ATTENTION: ONLY FOR 4.00" BORE SLIP IN CONVERSION CYLINDERS WHEN USING THIS PISTON WITH A 4.00" BORE SLIP IN CONVERSION CYLINDER AND A 96" OR 103" ENGINE CASE THE CLEARANCE BETWEEN THE PISTON SKIRT TO CASE MUST BE CHECKED AT BOTTOM DEAD CENTER.

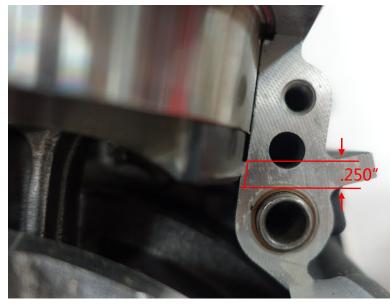
SOME CASES HAVE A LARGE CAST BUMP JUST BELOW THE MACHINED AREA FOR THE CYLINDER SLEEVE. THIS IS ONLY ON EACH EXHAUST SIDE OF THE CASE.

REMOVE THIS STEP TO RED LINE
